SUBJECT: Forwards "Independent QA Evaluation of Palo Verde Nuclear
 Generating Station Units 1, 2 & 3," Vol 1, "Executive
 Summary" Vol 2, "Program Results" & Vol 3, "Potential
 Finding Reports."

Subject: Docket Nos. 50-528/529/530, Palo Verde Nuclear Generating
Station, Independent Design Verification
File: 82-003-002

EXECUTIVE SUMMARY

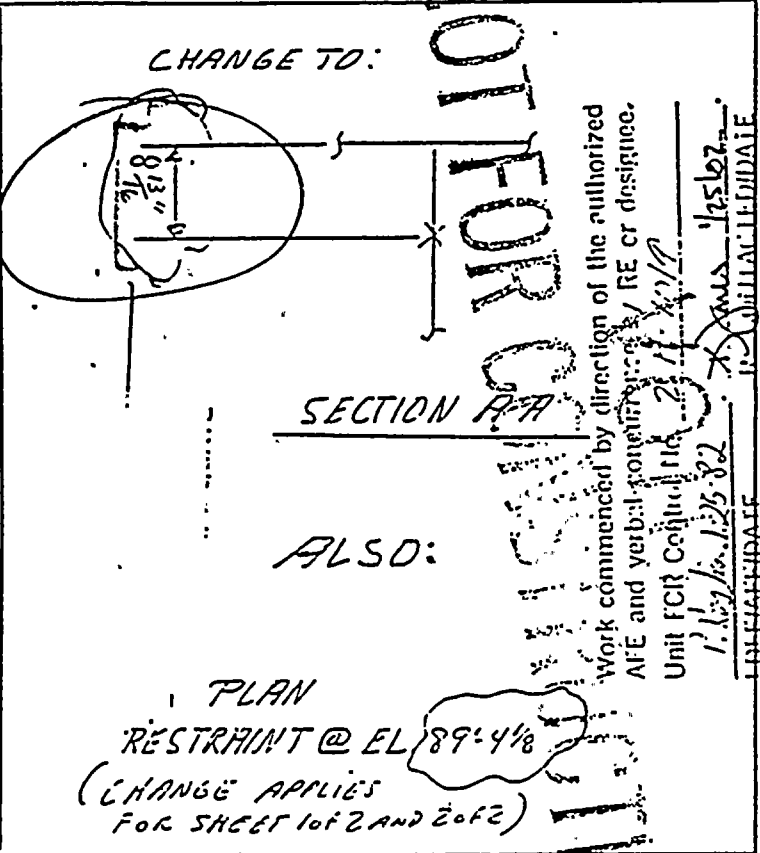
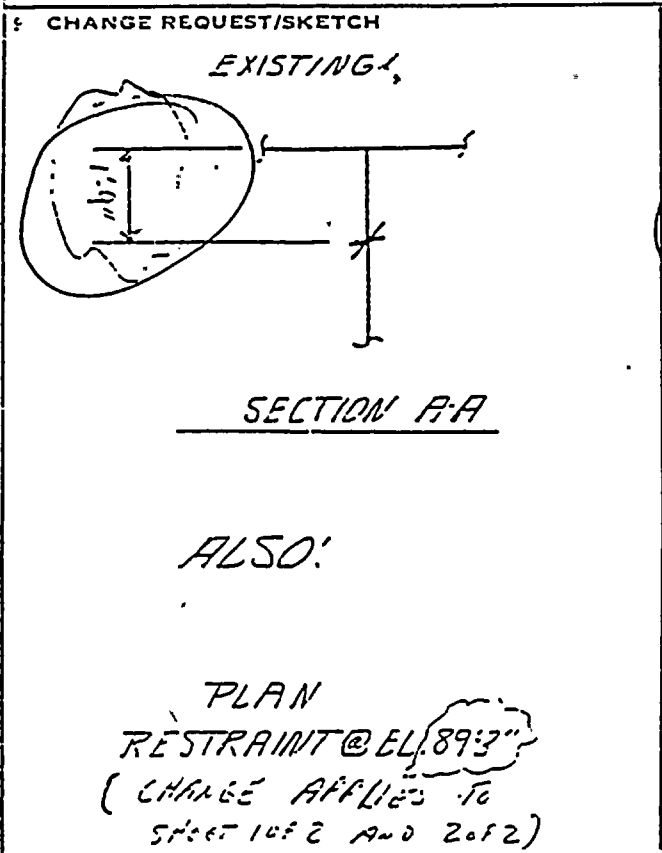
8. EXISTING CONDITION
CRITICAL DIMENSION IS IN ERROR 15.013 P.F.F.
122 FEET 7 SHOULD A RISER BETWEEN A 6" 90° ELBOW AT EL.
89' 3 1/8" AND THE AT 90° D.S. CHANGE CRITICAL DIMENSION
AS SHOWN BELOW. ALSO CHANGE RESTRAINT EL. 89' 3 TO 89' 4 1/8"

PHOTO 4 - IEZAIDH33

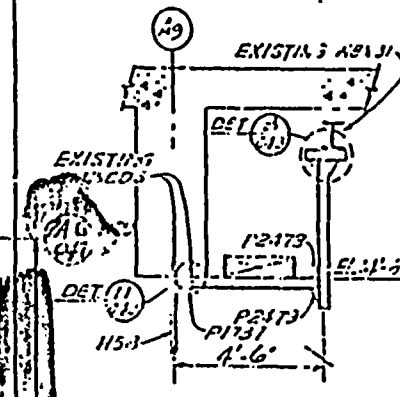
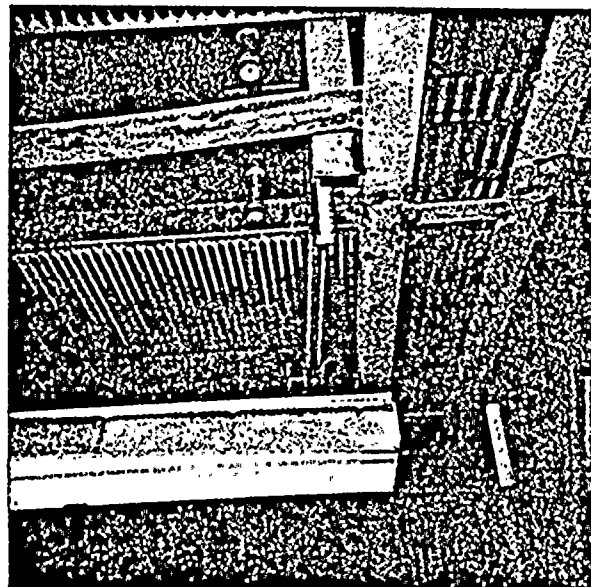
The drawing on 13-E-ZAC-037, Rev. 5 shows the support should be installed straight and perpendicular to the wall. Pictures 2-4 show that the free edge of the support has been forced out of position. The measurements made showed that the free edge of the support was displaced 1 3/8" out of perpendicular. The resulting displacement will induce bending moments into the support that have not been considered in the analysis.

H33 Support found skewed

SHOWS MISALIGNMENT OF SUPPORT RELATIVE
TO CABLE TRAY

SHOWS LONGITUDINAL BRACE THAT HOLDS
SUPPORT OUT OF ALIGNMENT

Cable Tray Support EZAI DH33 was installed and inspected in May, 1979, to drawing 13-E-ZAC-043, Revision 9. Note 14 stated, "When field conditions require, the details shown may be altered to fit, provided there is no loss of strength, stability or rigidity". The condition described in this PFR is acceptable under this criteria. Since this condition has been questioned by the Torrey Pines evaluation an engineering evaluation was conducted. This evaluation determined that the very small horizontal load caused by this condition causes a slight bending only in the vertical member in the Y direction. By inspection, the additional stresses from this condition will not affect the design of the support.

REASON: *Since the vertical leg is out of plant additional by only 1/50 and the loads are a small percentage of the design loads, the vertical member will be adequate. The horizontal members are straight not bent and therefore the only additional loads will be twisting moments which are also very small. The support*

9. CHANGE REQUEST/SKETCH <u>LISTED SPOOLS.</u>

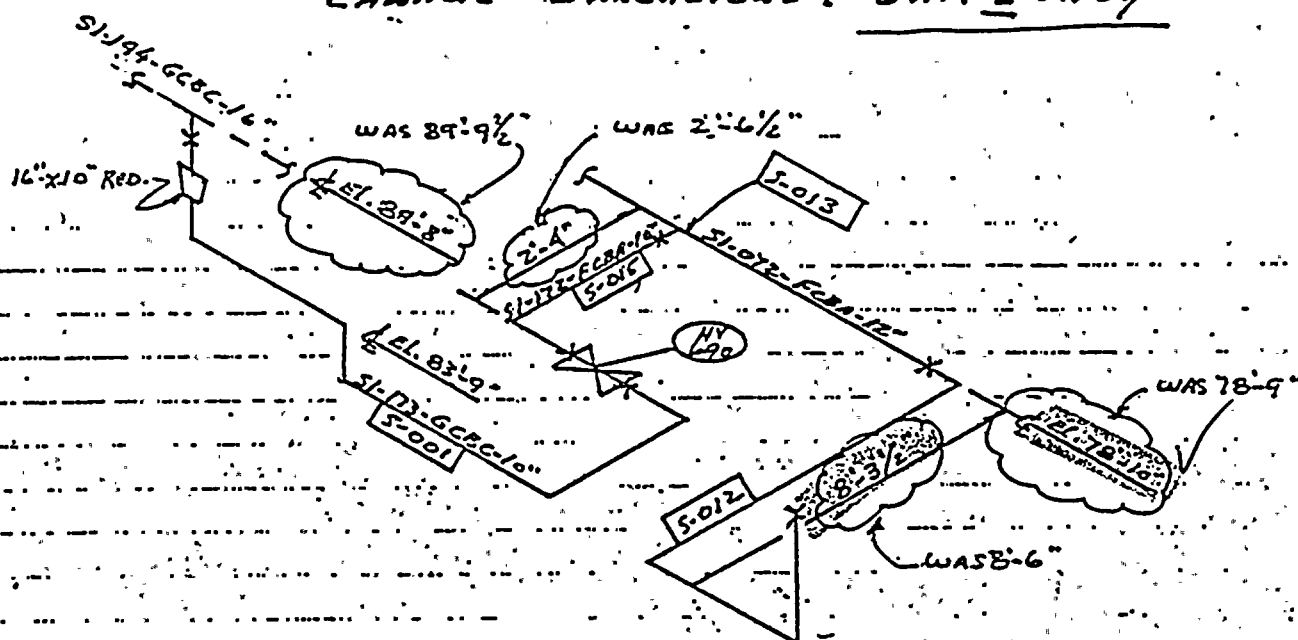
CHANGE DIMENSIONS. UNIT 1 ONLY

PEID 13-M-SIP-001-7

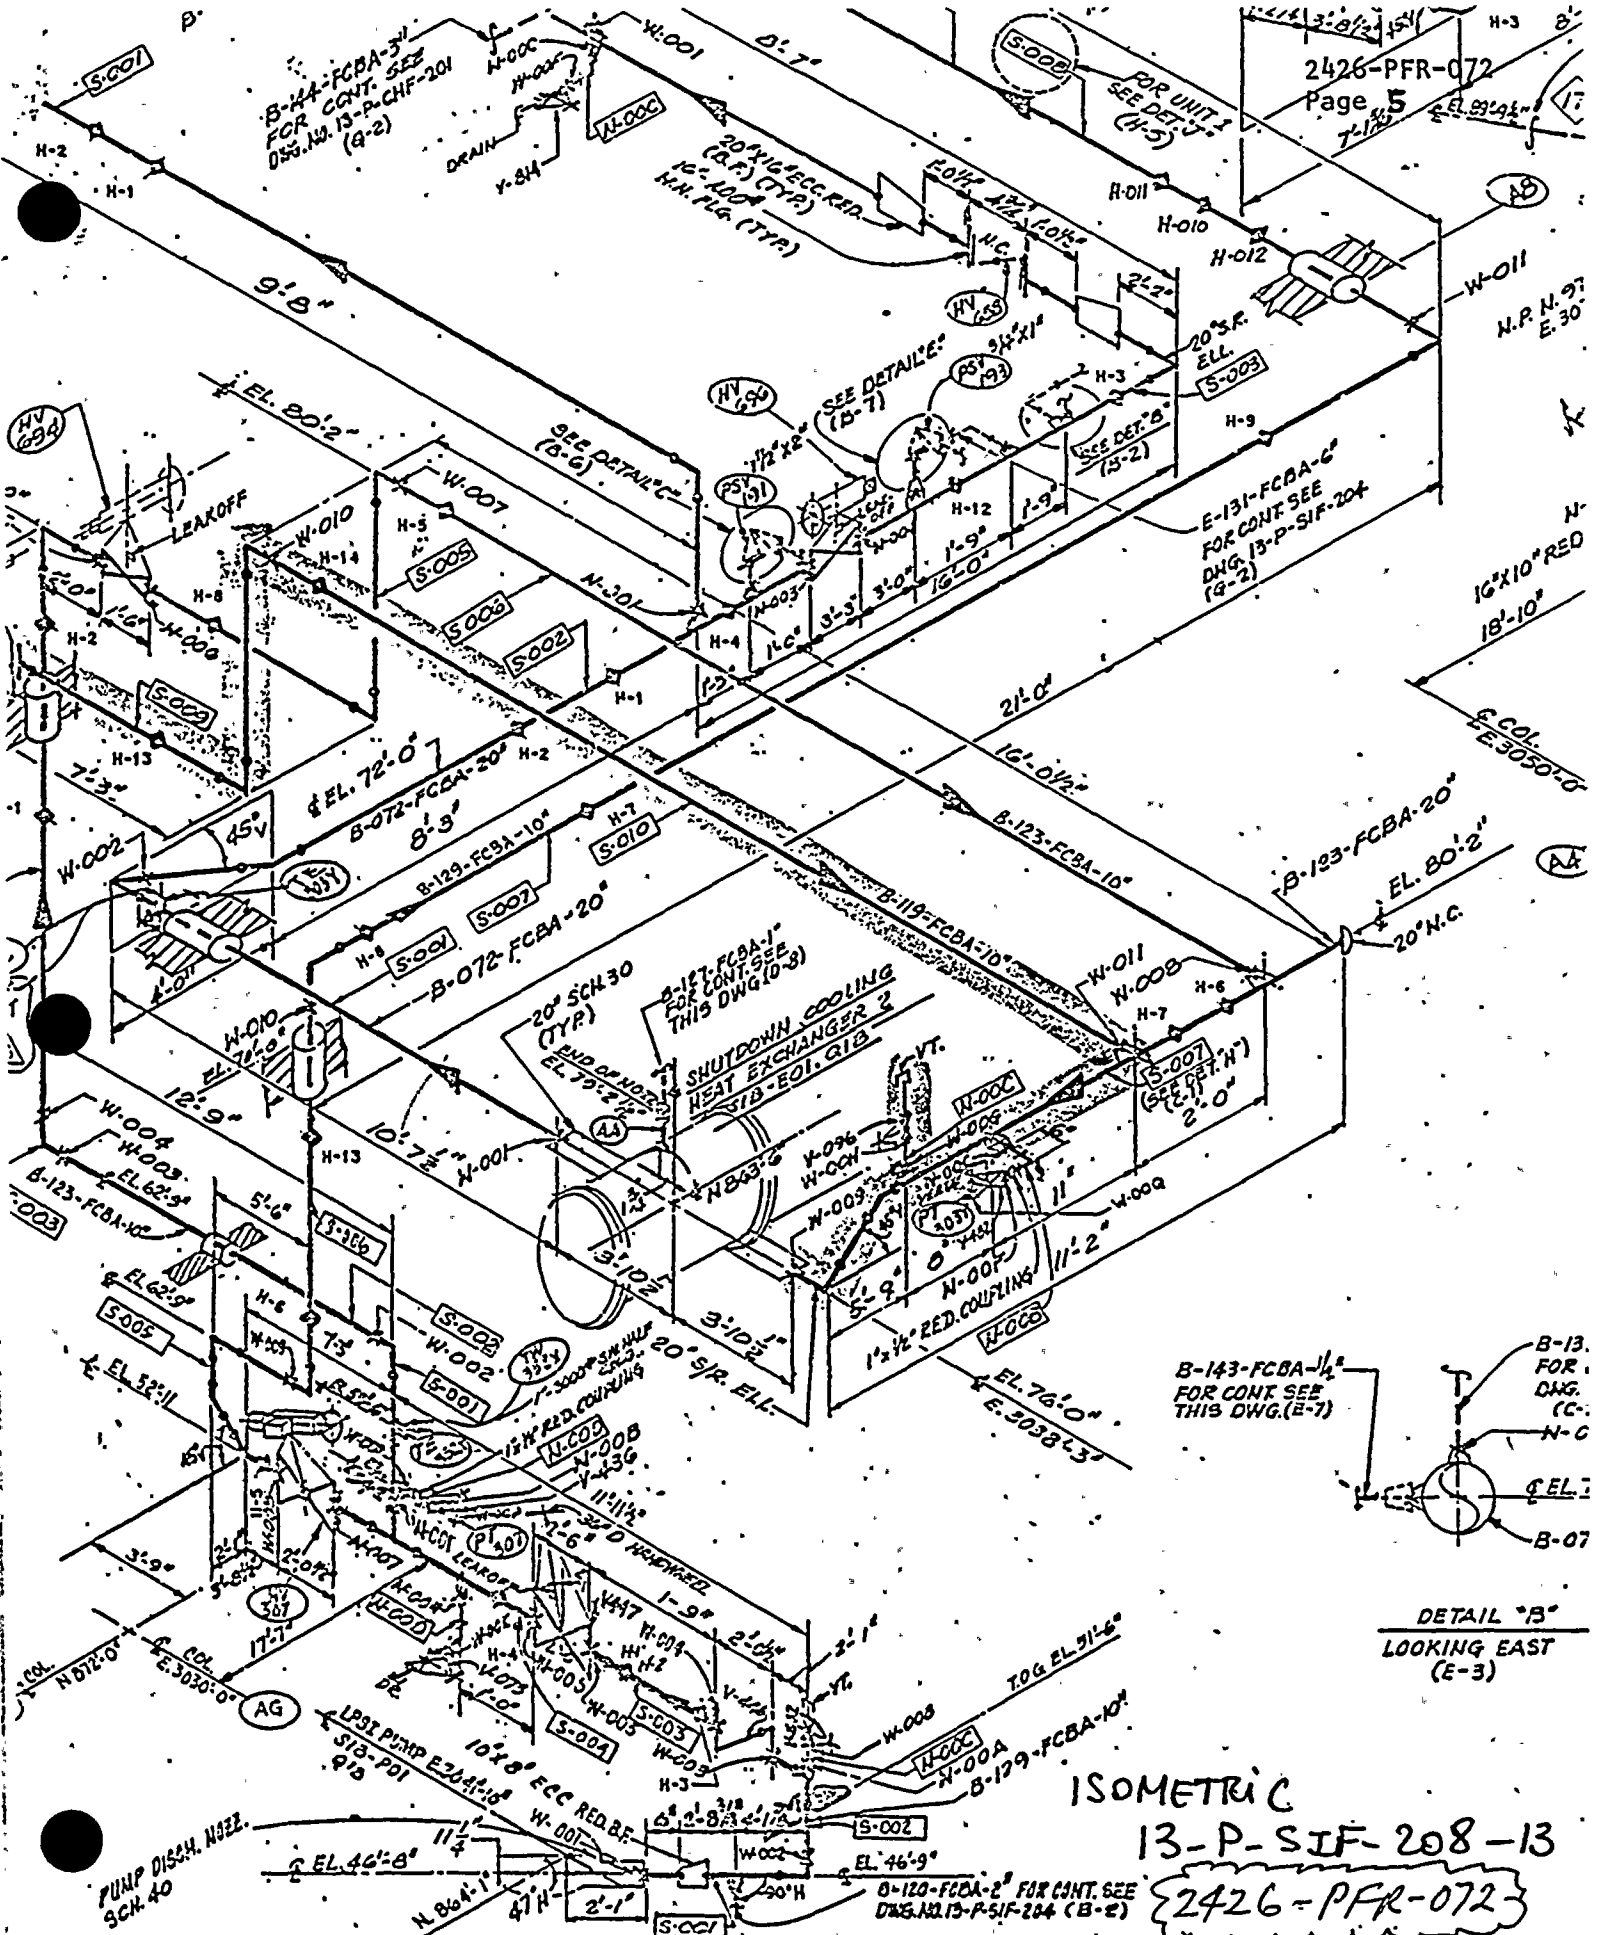
Drawing 13-M-SIP-001-7

Vent valve 2PS1BV096 and globe valve 2PS1BV482 are installed in accordance with drawing 13-P-SIF-208, Revision 13. Detail "H" shows the described condition for Unit 2 only. Therefore, the valves are installed per the drawing requirements. The P&ID referenced in the subject finding would not show this level of detail.

Detail 'H' on drawing 13-P-SIF-208, Rev. 13 clearly shows the Unit 2 arrangement. Plant is built per print. See attached ISO drawing.

DETAIL 14

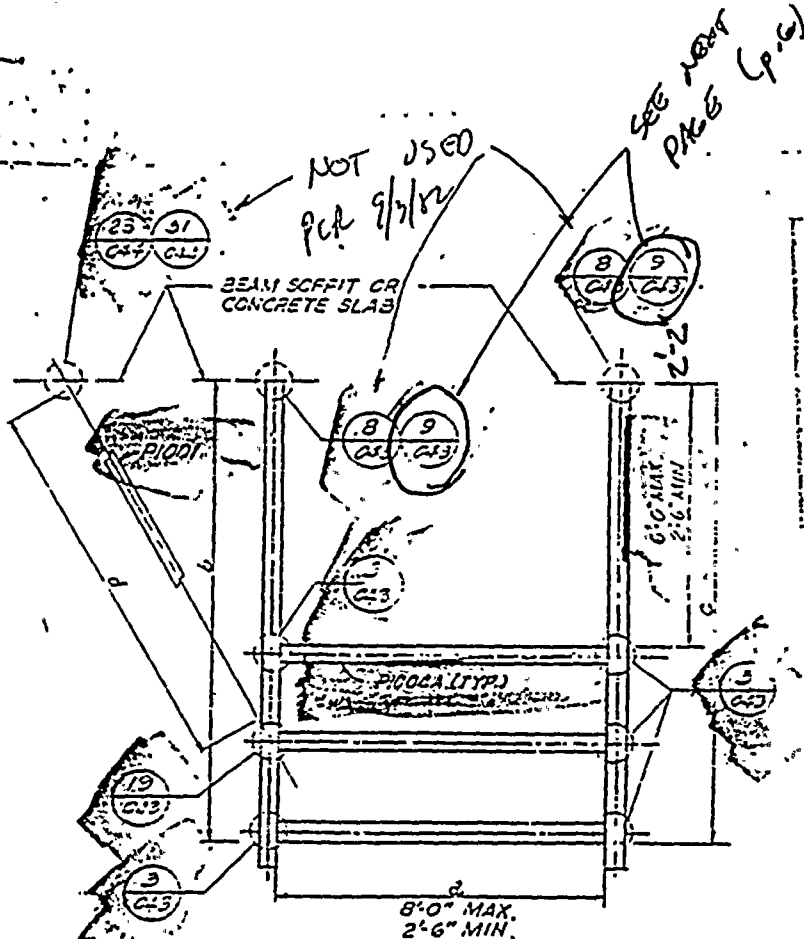
DESCRIPTION OF POTENTIAL FINDING: Detail 14 for the connect^{ion} between the vertical leg of the support and the bent plate requires a 1 1/2" long 1/8" fillet weld on each side of the unistrut when the support carries 6 or more trays. In the field, the weld is missing.

SUMMARY: THE CONNECTION DETAIL 14 FOR SUPPORT TYPE 23 WAS
DISCUSSED. THE CONNECTION IS DESIGNED TO HANDLE THE SHEAR
LOAD BUT I POINTED OUT THAT THE MOMENT CAUSED BY
THE ECCENTRICITY OF THE AXIAL FORCE COULD NOT BE CARRIED
BY THE DESIGNED CONNECTION. WING SAID THAT HE WILL CHECK
THIS CONNECTION AND SEND THE RESULTS TOMORROW MORNING.

Drawing 13-E-ZAC-043 allows the field to use Detail 14 for installation of cable tray support EZA1DH17, in lieu of Detail 8 or 9. Detail 14 requires a unistrut bent plate on only one side of the vertical unistrut support. However, note 3 to detail 14 requires the unistrut to be fillet welded to the plate whenever there are more than five (5) trays on the support. Cable tray support EZA1DH17, in Unit 1 supports nine (9) trays and therefore should be fillet welded.

Note 3 to Detail 14 was added to the drawing in March, 1981. The above cable tray support was installed and accepted in Unit 1 prior to this date. To address this and other similar situations, there is a walkdown of all Class 1E raceway supports by Engineering and QC. This walkdown is required by DCP 1SC-ZJ-083 and is currently in progress. The walkdown will evaluate and validate the subject raceway supports.

The referenced TPT Impact statement for PFR-074 indicated that the Type 23 cable tray connection (Detail 14 on dwg. 13-E-ZAC-043) was inadequate. This detail was analyzed and found to be adequate due to the stiffness contribution by the attaching structural members. These calculations, see attachment 1, were evaluated by TPT and they agreed with the above conclusion. However, TPT also determined that the vertical Unistrut member P1001A3 would be overstressed due to the additional moments not previously considered on that member. See attachment 2.

In Block 10 of the CAR, the finding should be classified as generic since connection Detail 14 is used throughout the plant design. The details needed for the revised Corrective Action Plan are: 1) Date of completion for the evaluation of connection Detail 14 and any subsequent physical corrective action, 2) to evaluate the acceptability of Detail 14, both the connection and the connecting members will be analyzed and if either is found to be overstressed a specific physical design correction will be developed and installed.

EZAIDH17

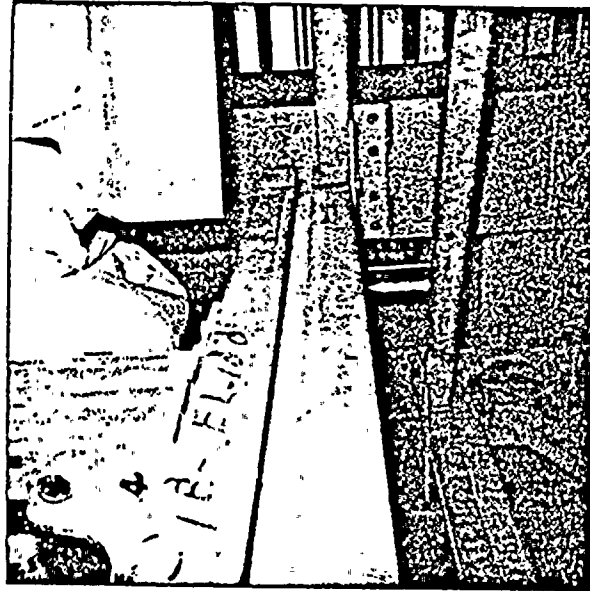
CONNECTION OF INTEREST
AT THE TOP OF THIS LEG

CONNECTION OF INTEREST
AT TOP OF THIS LEG.

CONNECTION OF INTEREST AT THE
TOP OF THIS LEG
